SECTION 00 91 02
ADDENDUM NUMBER 2

DATE: AUGUST 30, 2022
PROJECT: KEN PICKERILL HOUSE RENOVATIONS
6350A MINKLER ROAD
YORKVILLE, ILLINOIS 60560
PROJECT NO: 19-429-1250
OWNER: KENDALL COUNTY FOREST PRESERVE DISTRICT
110 W. MADISON STREET
YORKVILLE, ILLINOIS 60560
TO: PROSPECTIVE BIDDERS / PLANHOLDERS OF RECORD

THIS ADDENDUM CONSISTS OF 2 PAGES AND DRAWINGS A311, A331, A700, S311, S321 & S400.

CANOPY & PATIO PLAN

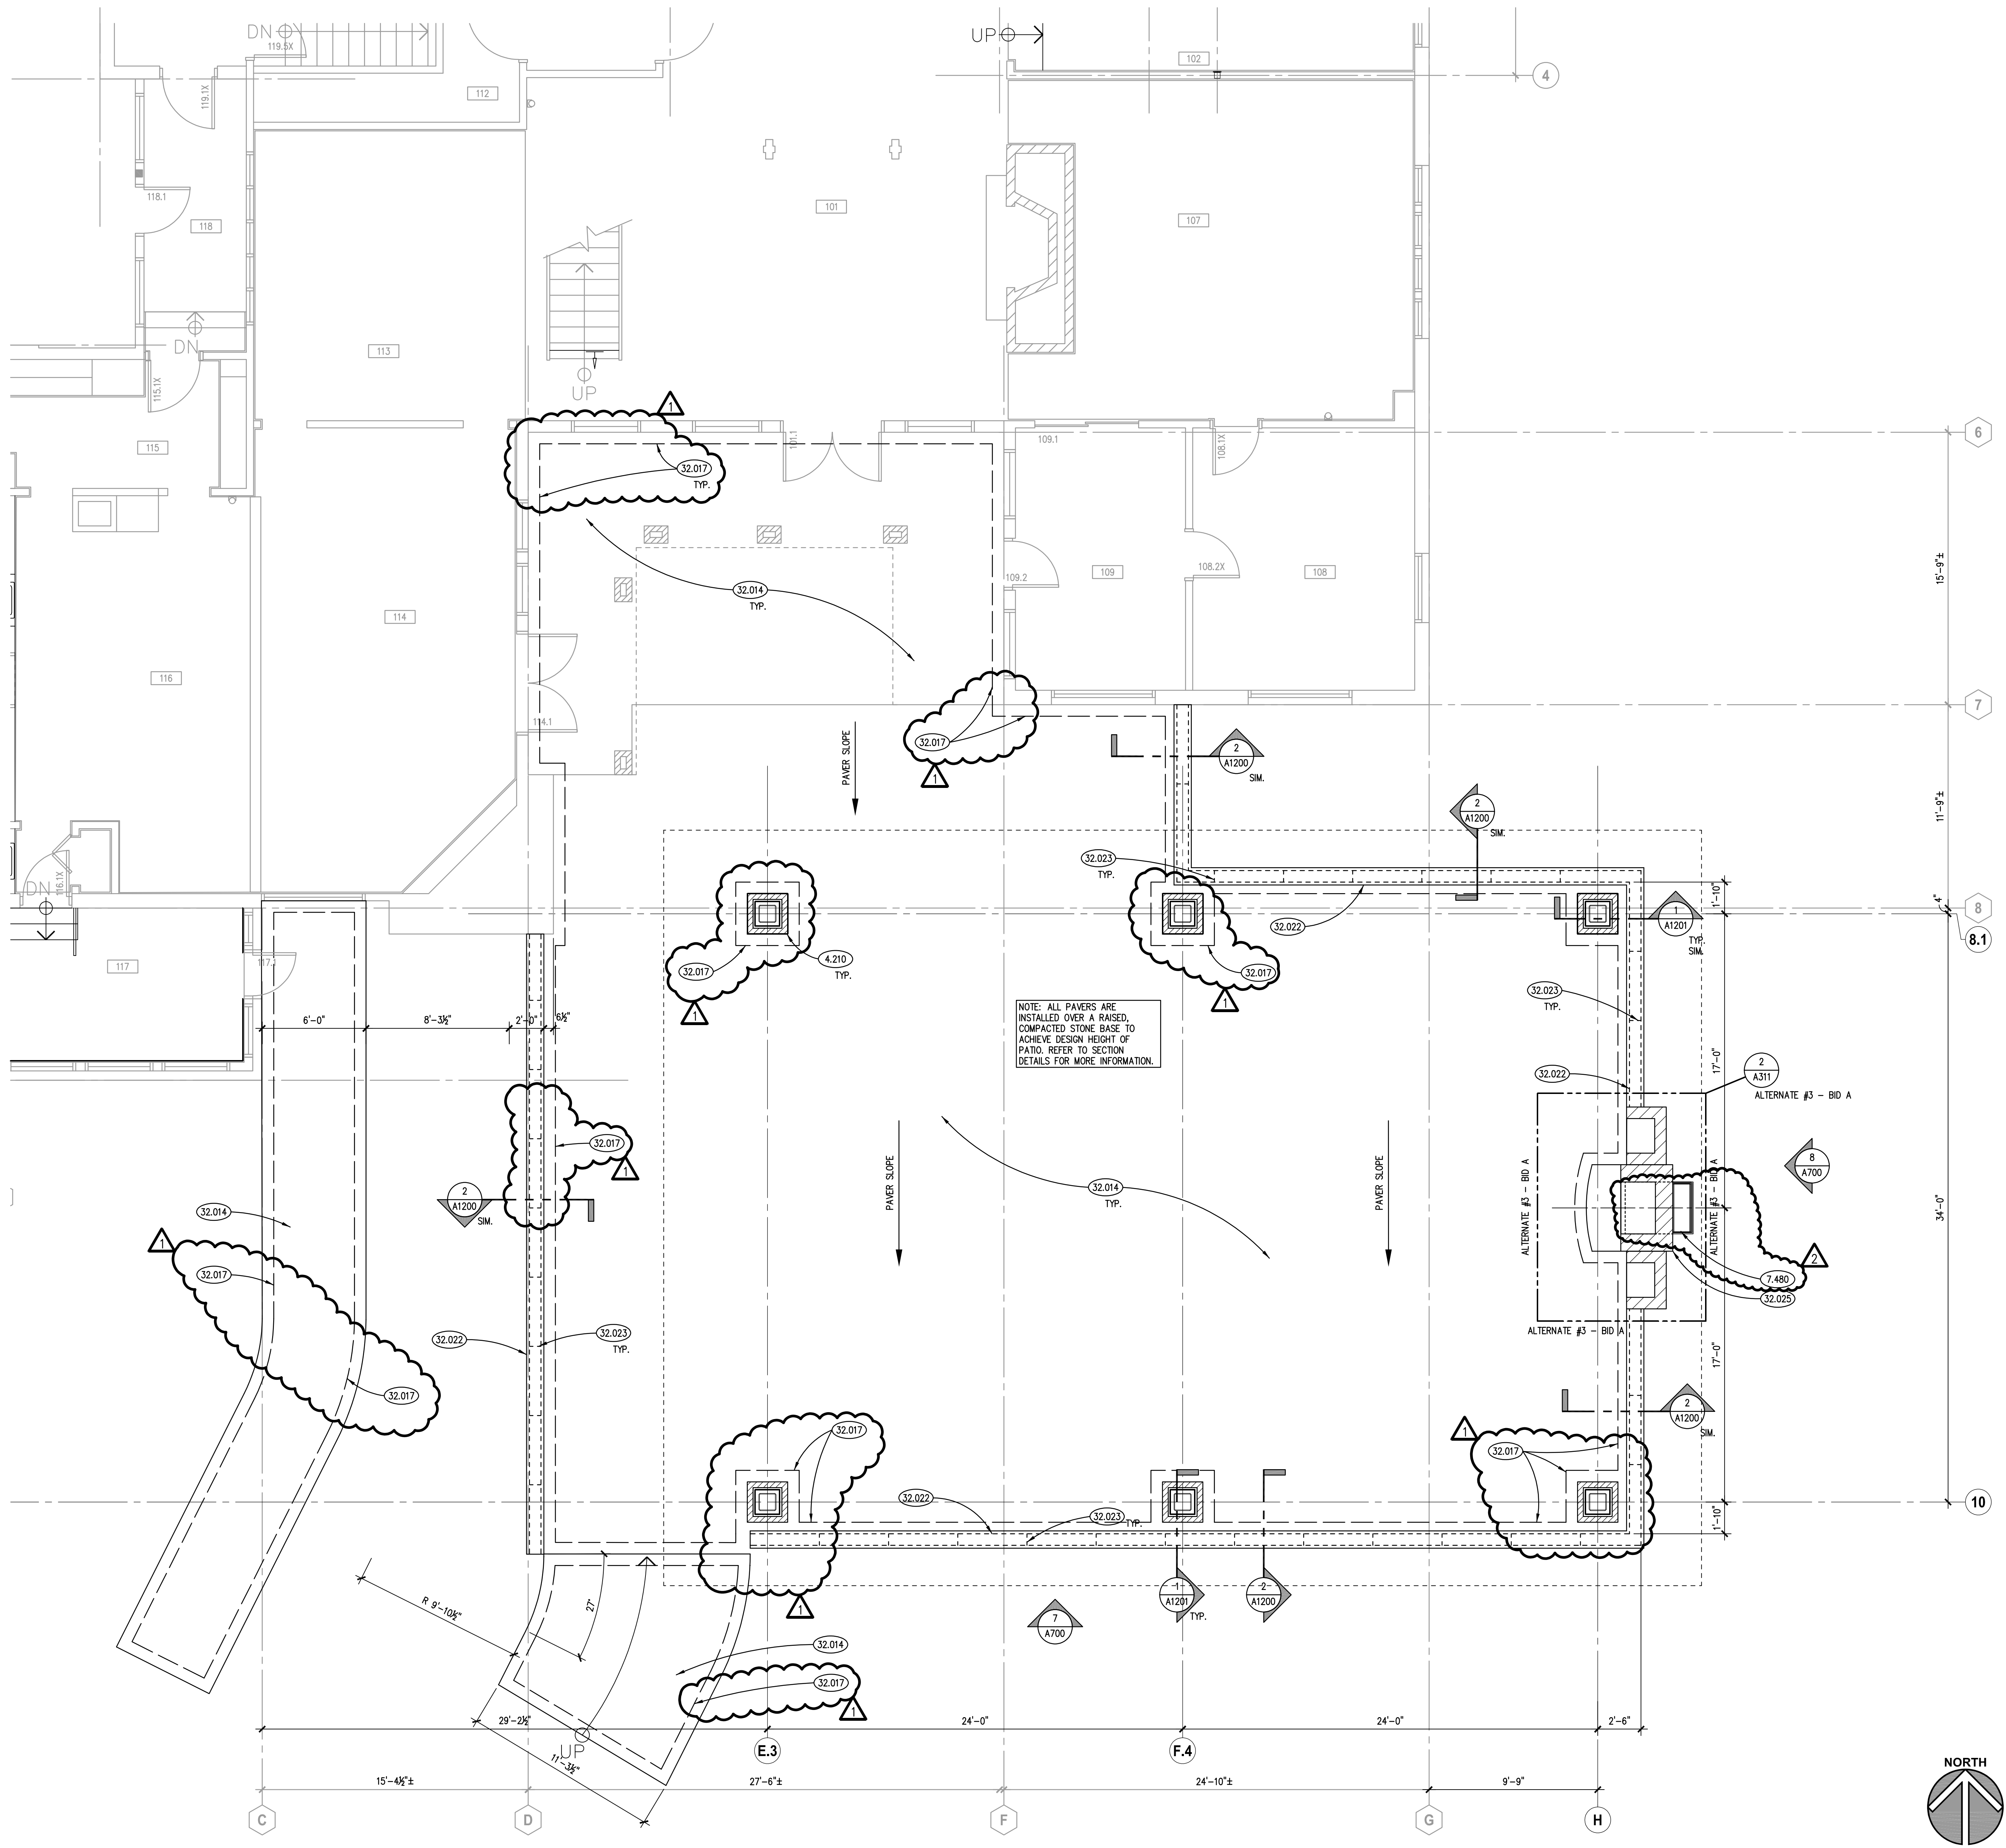
3.01 DRAWING A311 - CANOPY AND PATIO PLAN

A. Revised concrete / chimney foundation and chimney design as shown. Added Keynote 7.480 for framed chimney construction.

CANOPY ROOF PLAN
SCALE: 1/4" = 1'-0" **1**

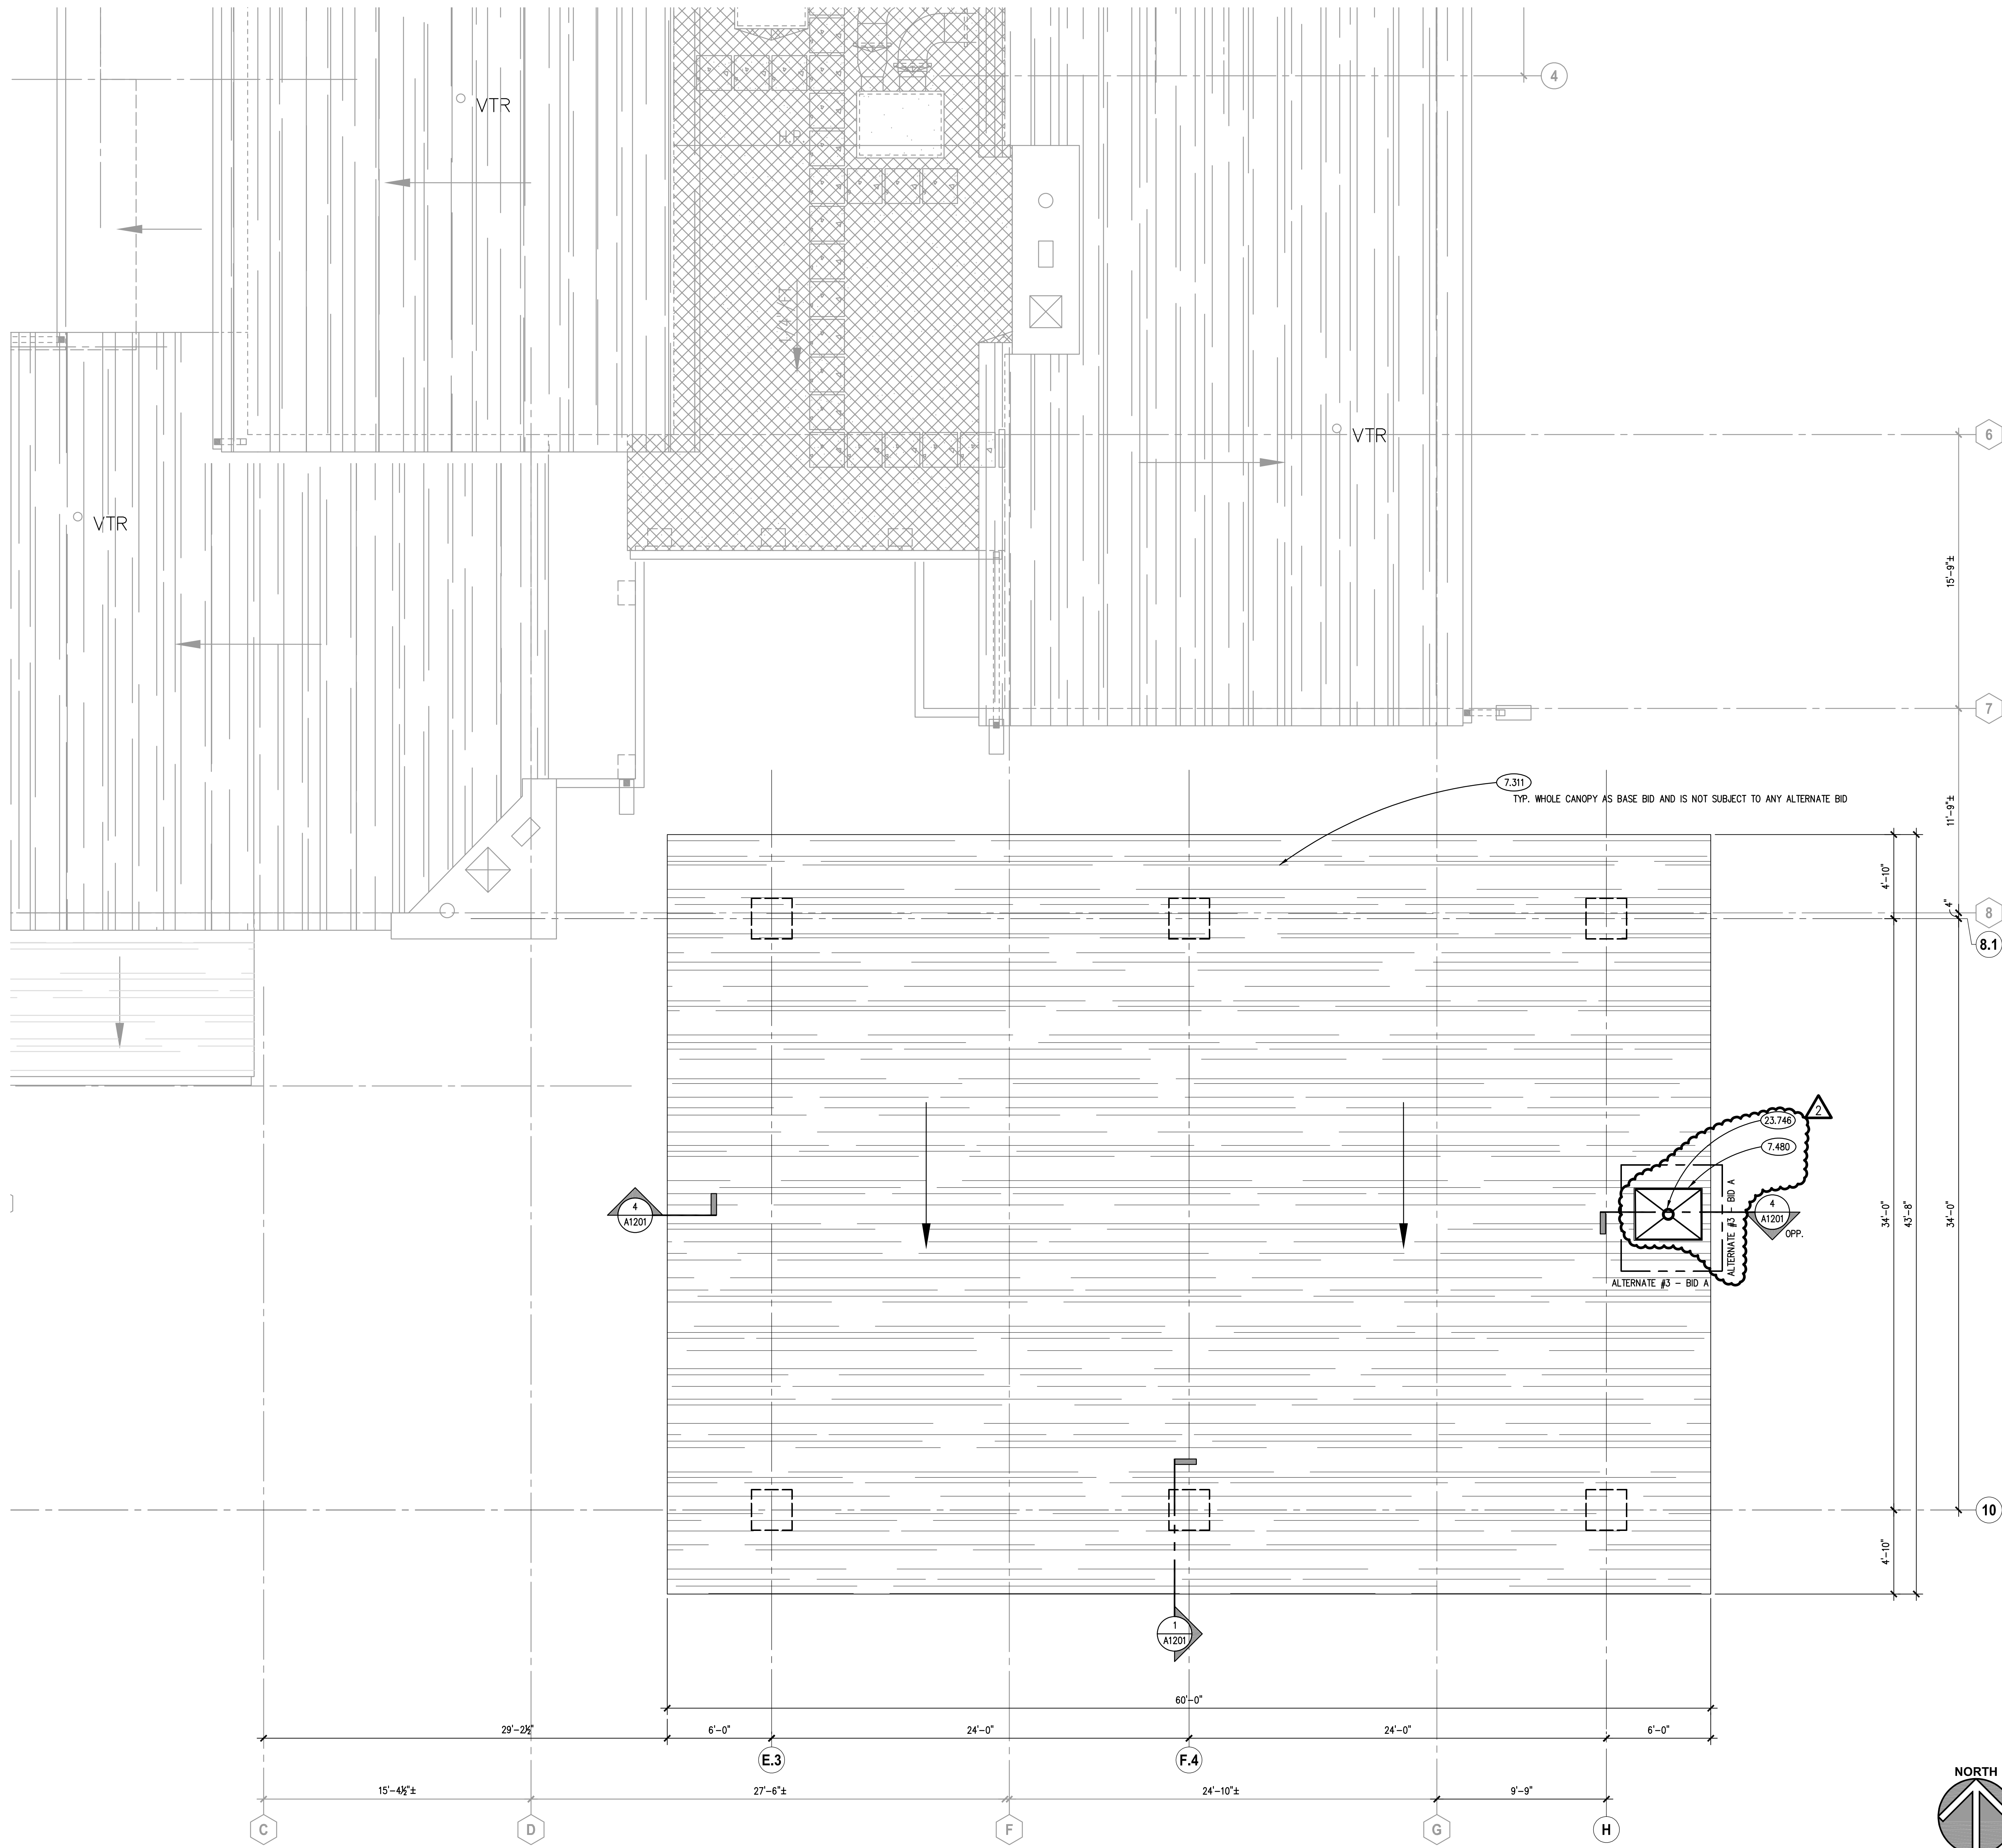
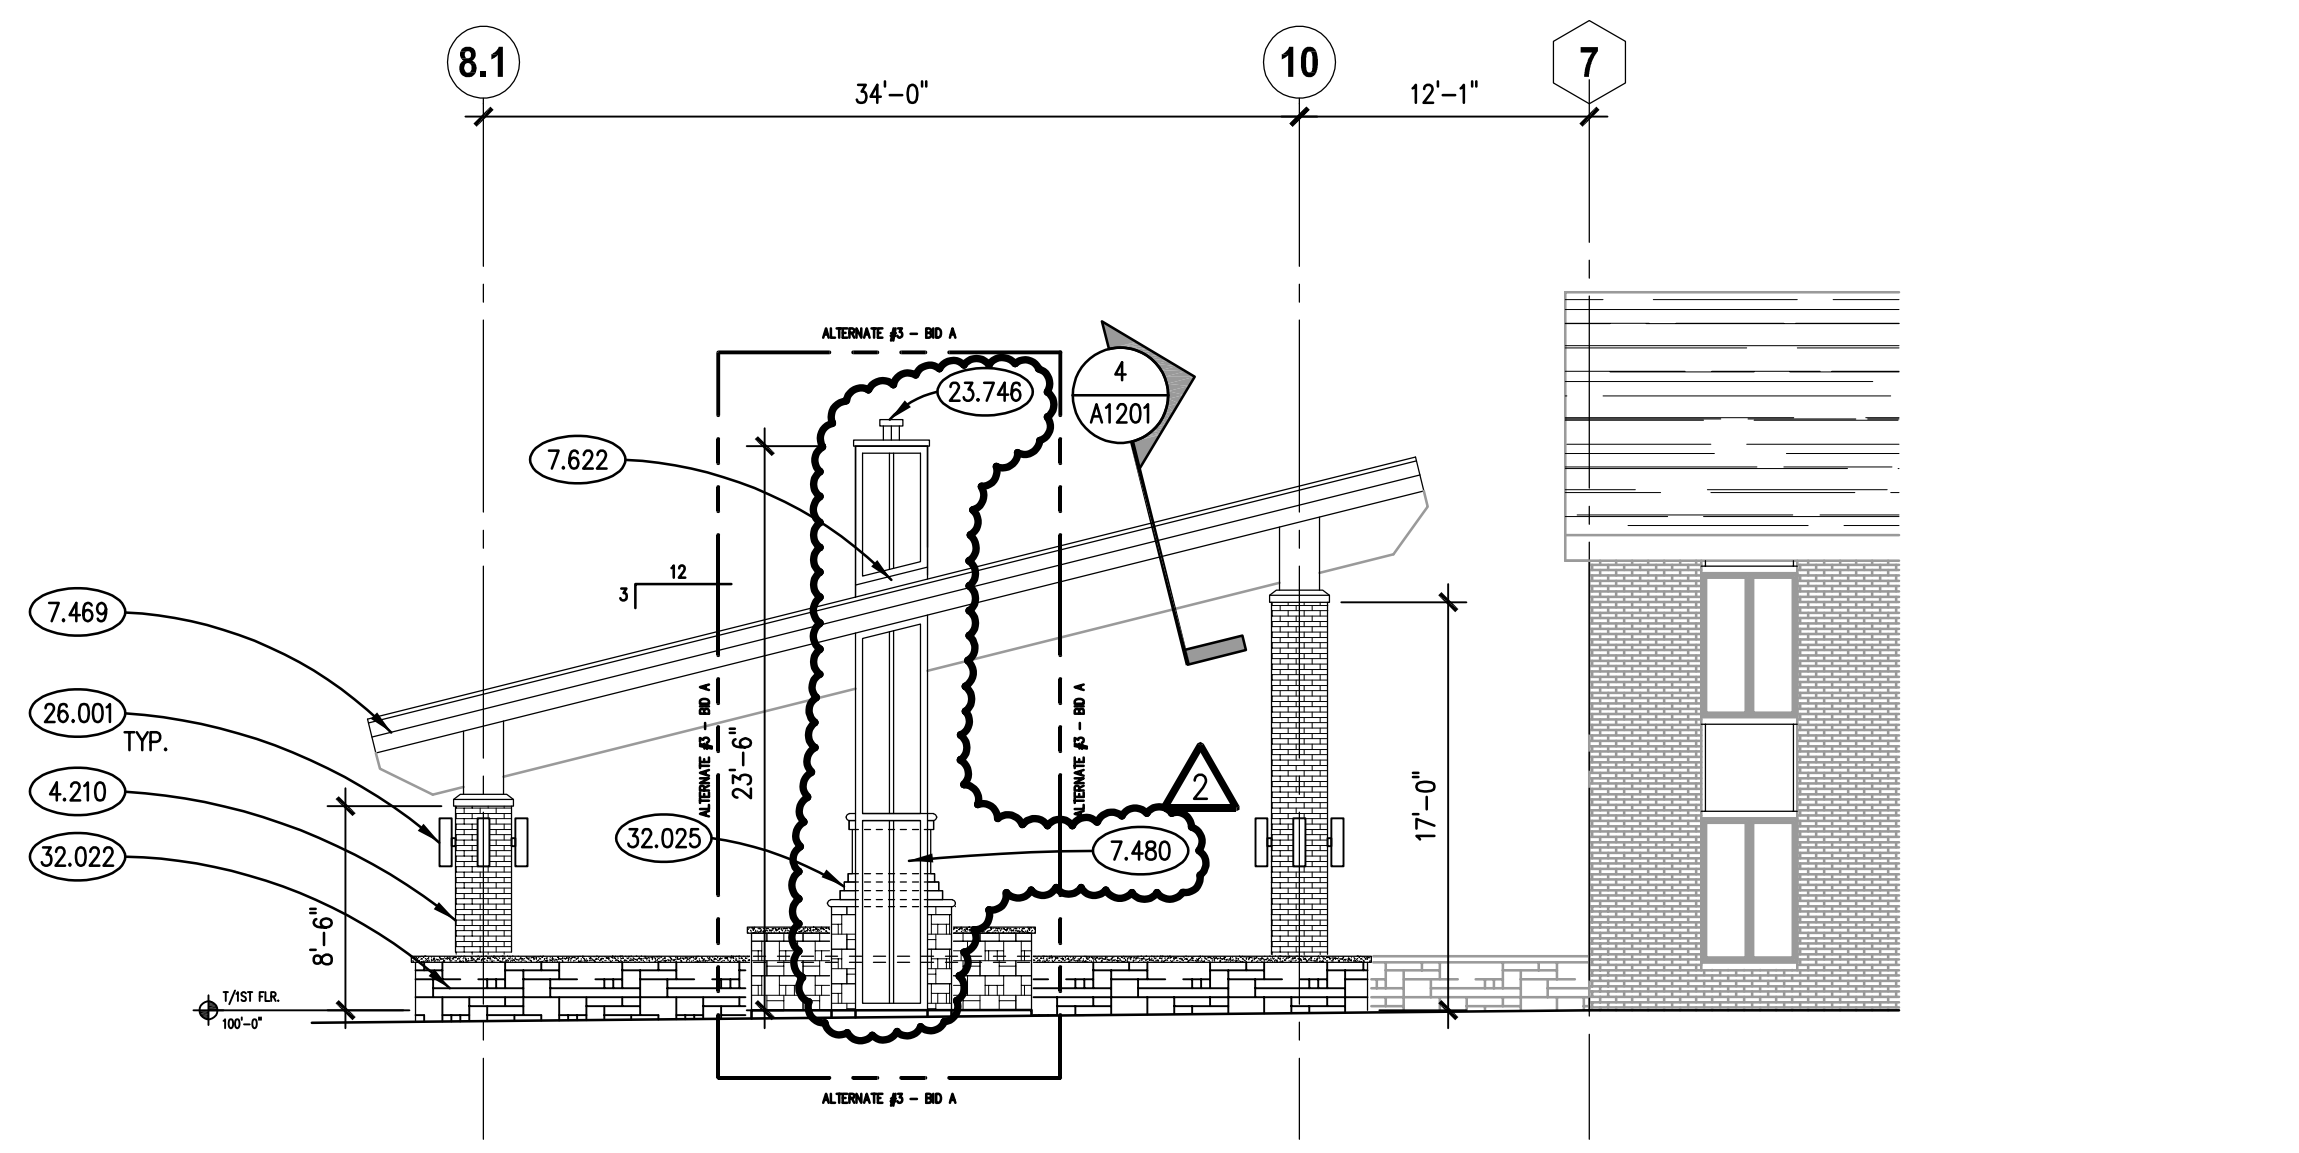
3.02 DRAWING A311 - CANOPY ROOF PLAN

A. Revised fireplace chimney through roof to be framed construction in lieu of masonry construction. Added Keynotes 23.746 and 7.480 to chimney as noted.
